Technical Bulletin 078

Title: Vaillant ecoMAX and ecoTEC ranges of boilers – Product modification and servicing reminder

Date issued: 1 July 2015

Figure 1: Burner door

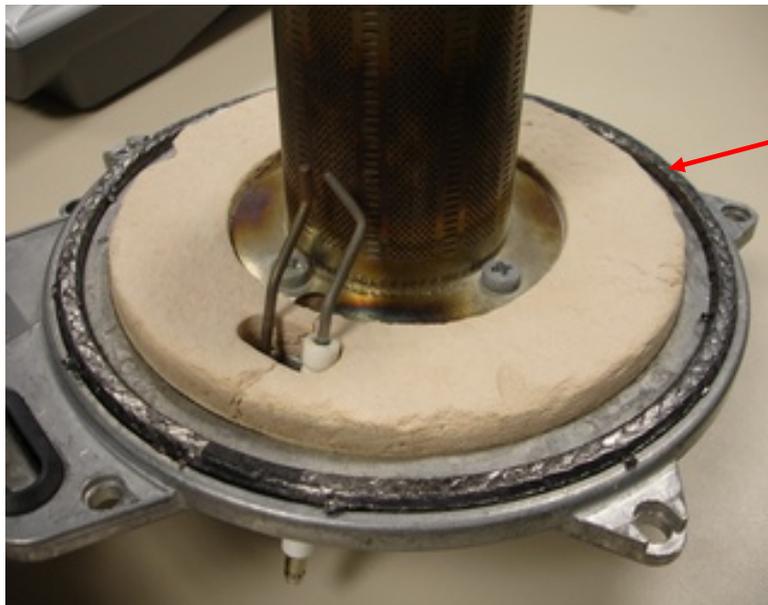
All of the above boilers produced **before** April 2006 were fitted with a silicon seal between the burner door and main heat exchanger (see Figure 1 below).

From April 2006, a new graphite seal was introduced which provides the following significant benefits:

Important Note: *If any of the boilers on the above list (i.e. those produced **before** April 2006 and still fitted with a silicon seal) have not been serviced for an extended period, there is the possibility that the silicon seal could degrade over time to the point where heat can escape into the boiler inner casing. If left for an extended period without attention, this can result in distortion of the burner door and/or plastic components internally within the boiler being damaged through overheating.*

Where a registered engineer becomes aware of any of the above central heating boilers during the course of a visit to a property, the boiler should be checked, paying particular attention to the burner door/heat exchanger seal (as shown in the Figure 1). If the engineer believes that the appliance is of the type with the older silicon burner door/heat exchanger seal, the engineer should apply the current Gas Industry Unsafe Situations Procedure (GIUSP), as described below:

Important: If the burner door is removed for any reason a new graphite seal must be always be fitted.

- Where the seal has become defective and/or damage has occurred to the burner door or plastic components within the boiler then the appliance should be classified as 'At Risk' (AR) in accordance with the procedure detailed in the current GIUSP.
- Where there are **no** signs of distress and the appliance is otherwise operating safely, make arrangements to replace the seal as soon as possible.

In light of the significant benefits of the new graphite seal, Vaillant are strongly recommending all registered engineers to replace the existing silicon seal with a new graphite seal at the time of normal annual servicing on any of the above boilers. Full instructions for the replacement of the seal are included within the packs.
